**ADDENDUM NUMBER 02**

**Project No. 22009 / 23007**  
**Sandusky County EMS**  
**Life Squad Station 14 / SCEMS Administrative Offices & Life Squad Station 18**

This Addendum supplements and amends the original Drawings and Specifications dated **October 24, 2024**, and shall be taken into account in preparing bids and becomes a part of the contract documents. Note: this addendum information is issued to bidders of record. It is the prime contractor's responsibility to forward this Addendum information to all affected suppliers and sub/contractors and make adjustments relative to the proposal. Bidders should acknowledge receipt of Addendum on Page BF-1 of the Bid Form, or the last page of this Addendum.

BID DRAWINGS  
DRAWING NUMBER:  
**C2.0**

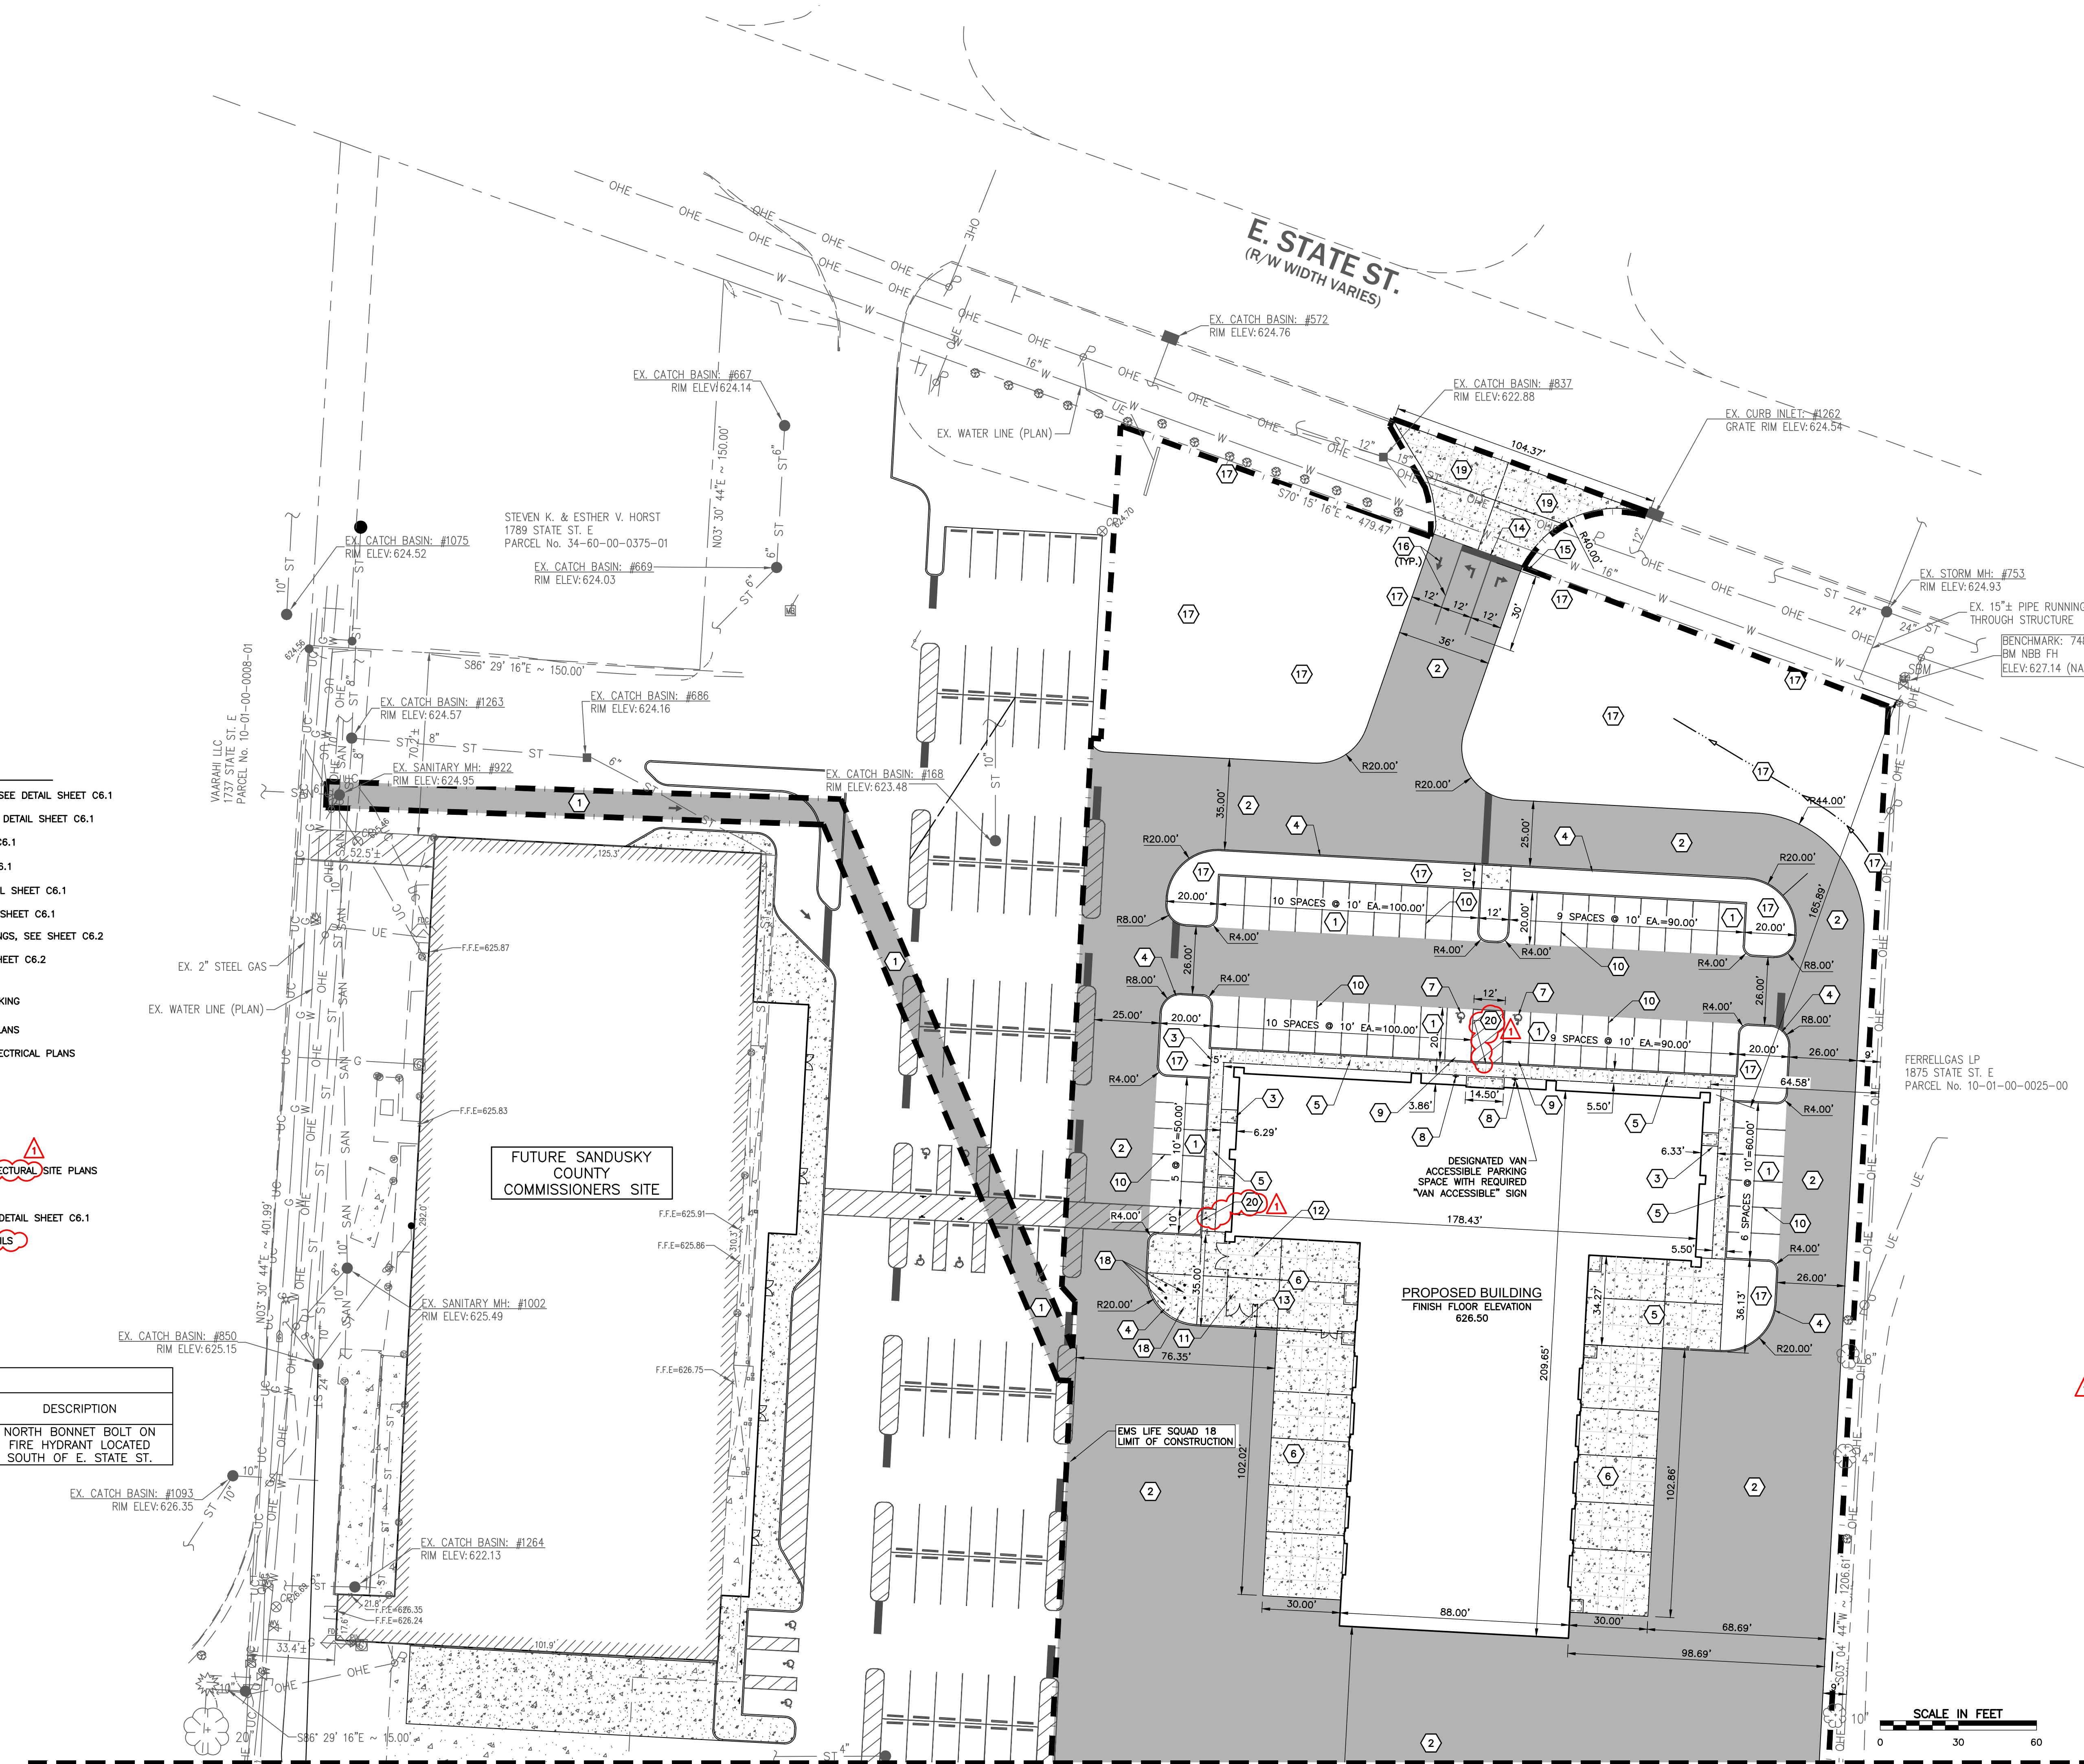
6. **C2.0 (REISSUED)**
  - a. The limits of the pavement removal and detention basin have been updated on the site plan.
7. **C2.1 (REISSUED)**
  - a. Key Note 17 has been revised to read "Architectural" Site Plan

1 SECOND FLOOR MEZZANINE PLAN  
A2.3 1/8" = 1'-0"

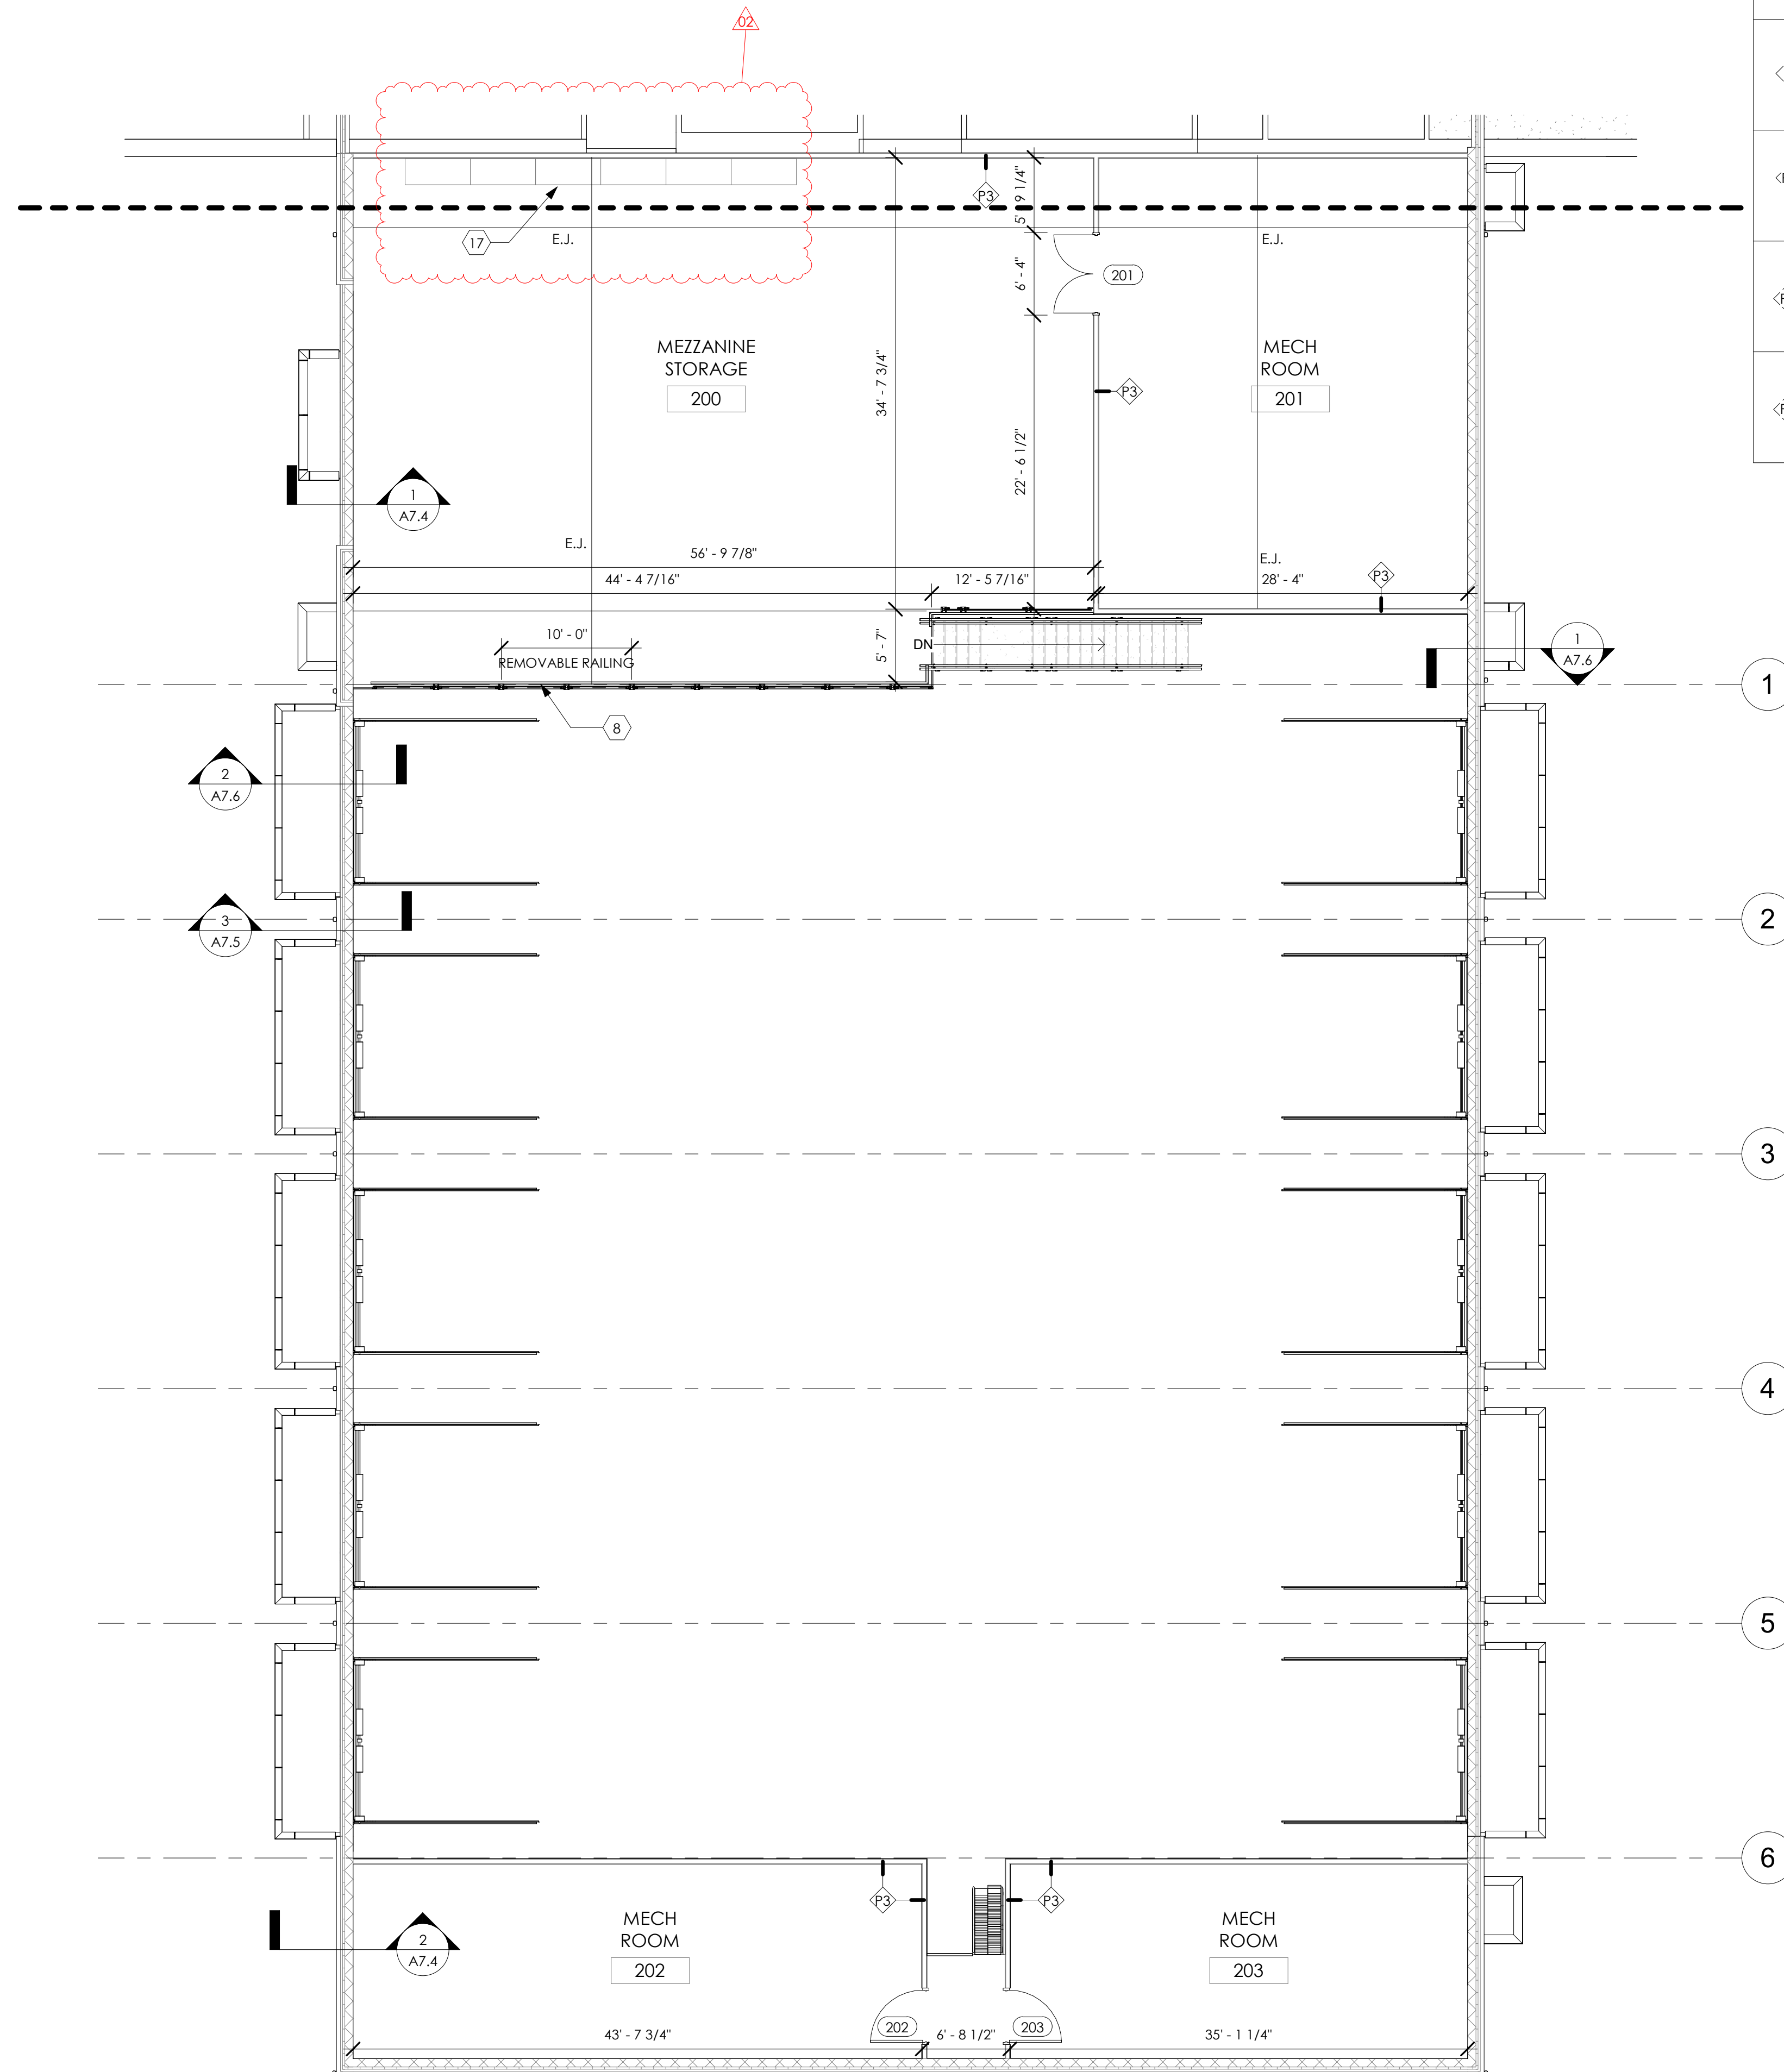
- a. **Plan 1/A2.3**
  - i. In Mezzanine Storage room 200, added post and beam shelving layout and key tag for note 17

- i. 140 System Wide Storage: Quantity: 18
- ii. 200 Mezzanine: Quantity: 6
- iii. Location: See updated sheet A2.0 / A2.3 for keynote callouts of the locations of shelving. Final location of shelving on mezzanine to be coordinated with owner and architect

**4 ROOF DETAIL**  
A4.3 3' = 1'-0"

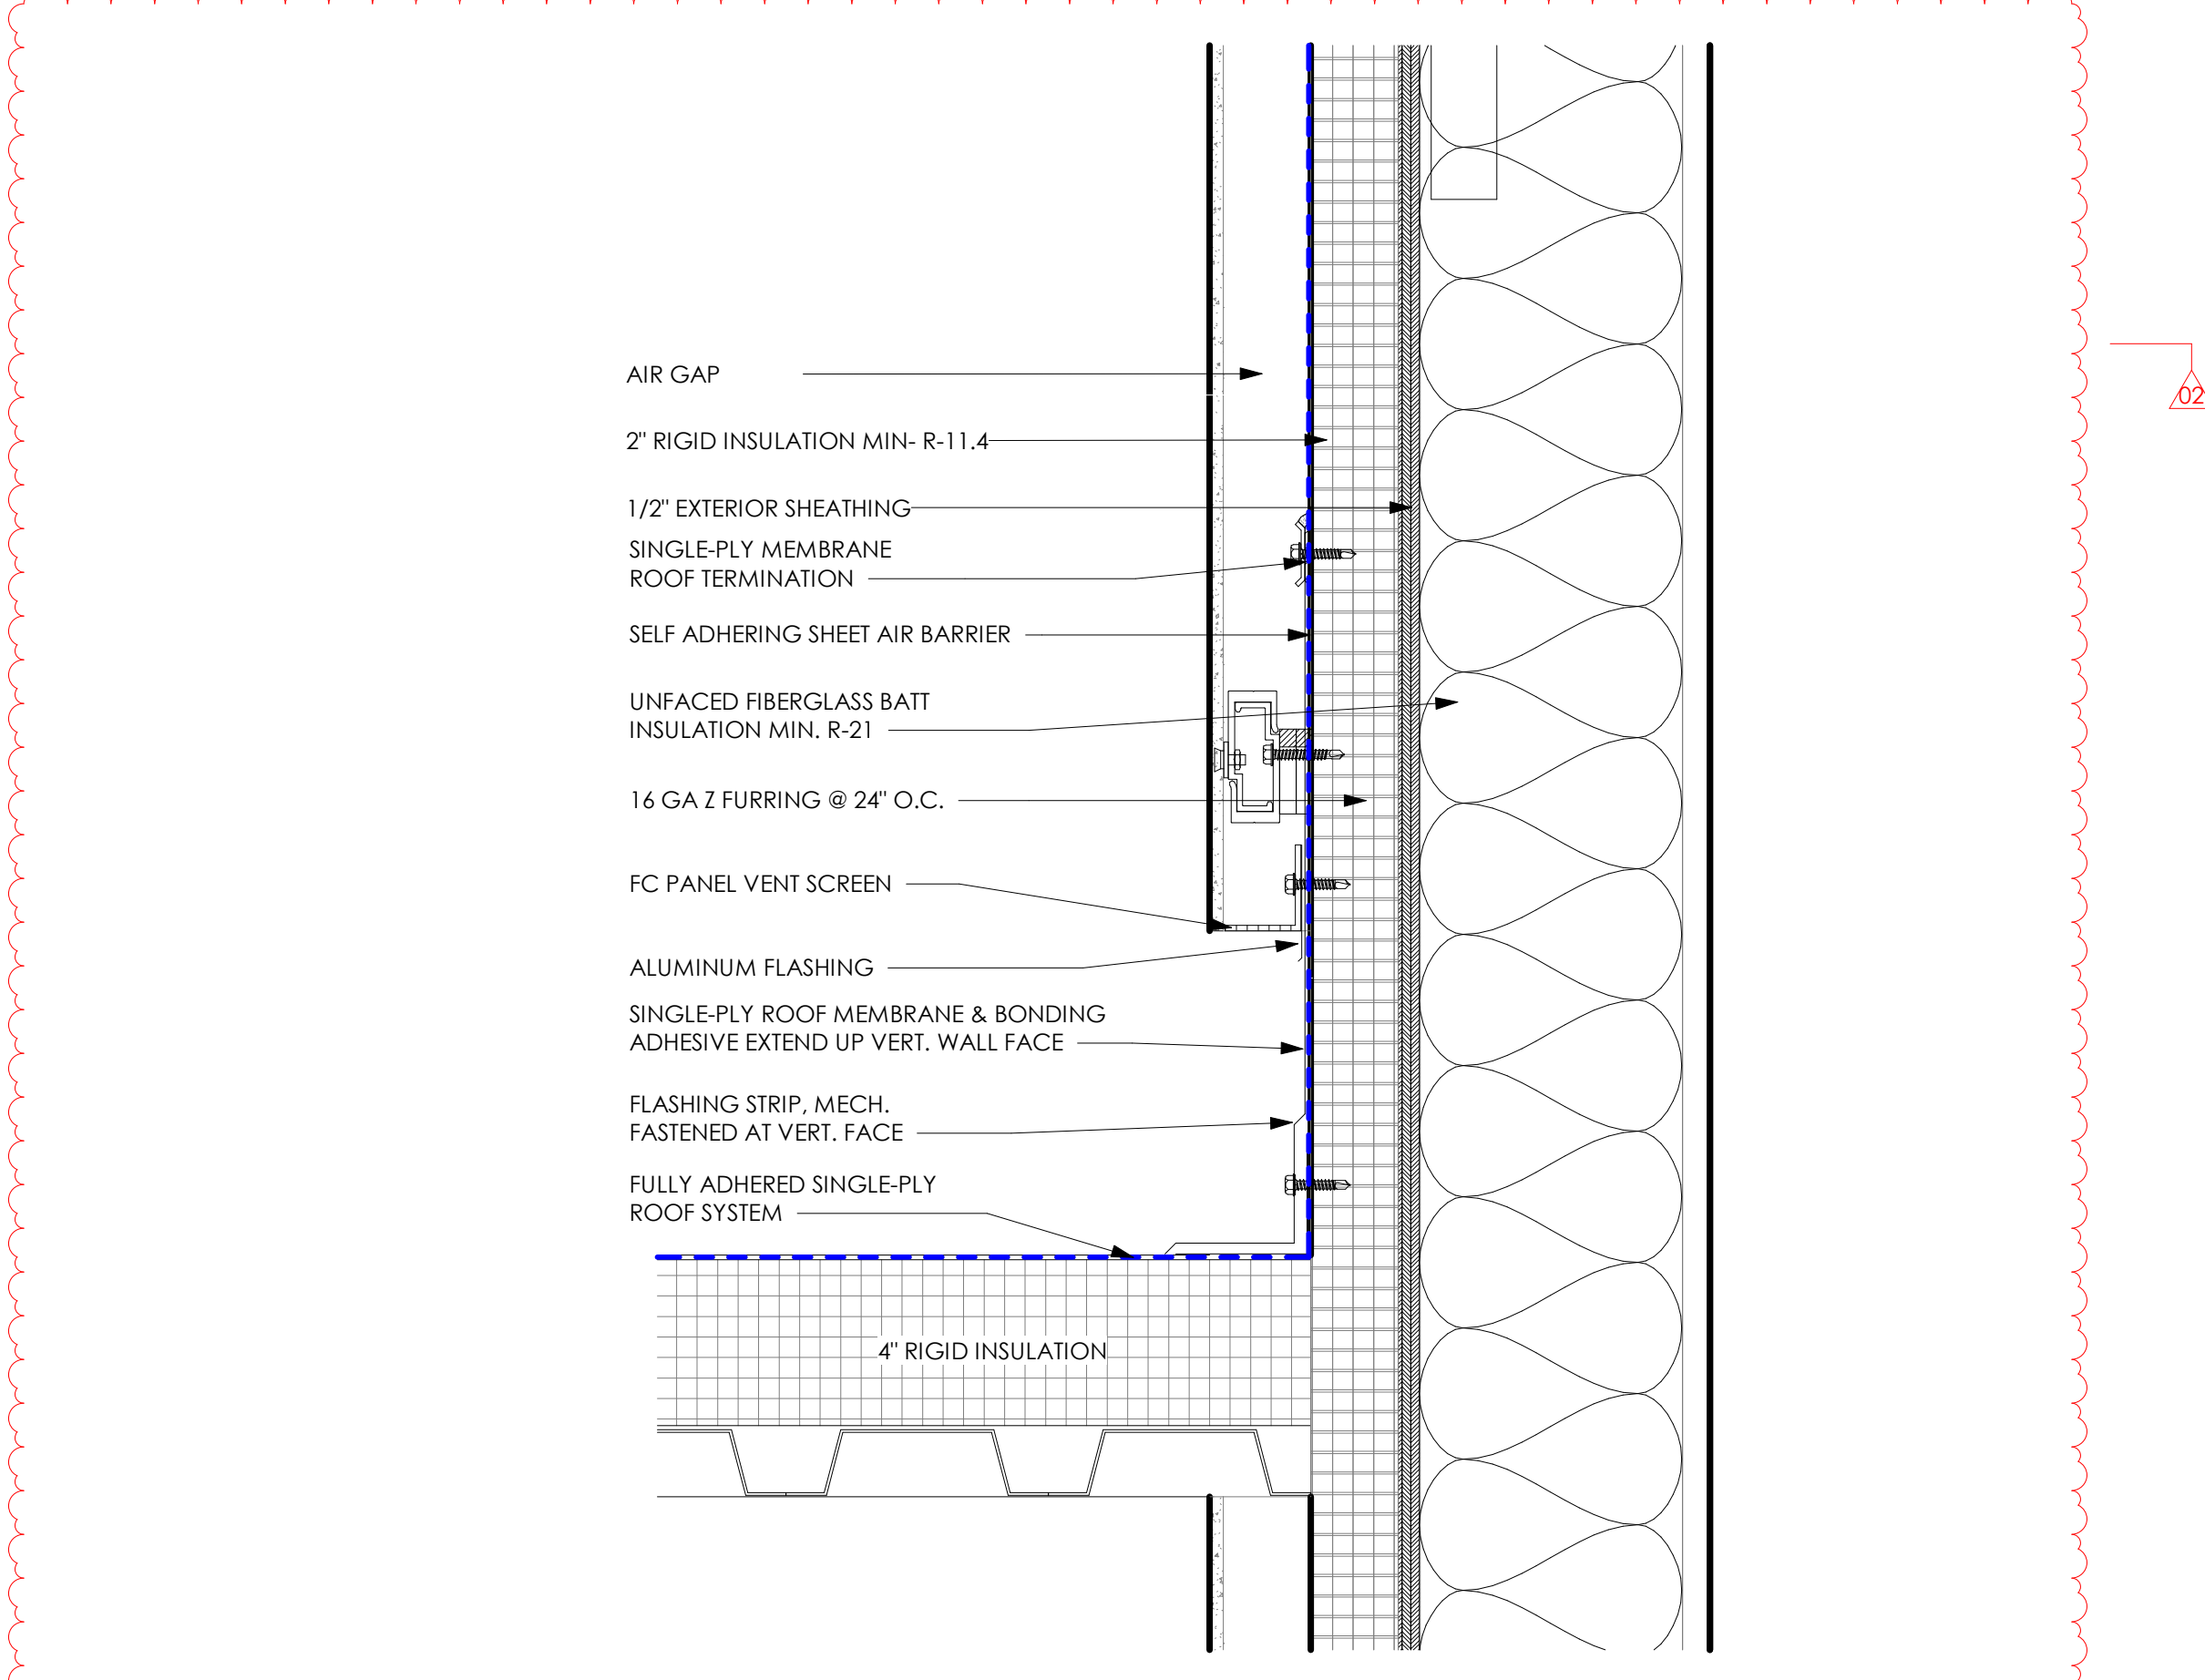
- a. **Detail 1/A4.3:** Added a callout for roof detail 4/A4.3
- b. Added roof detail 4/A4.3.
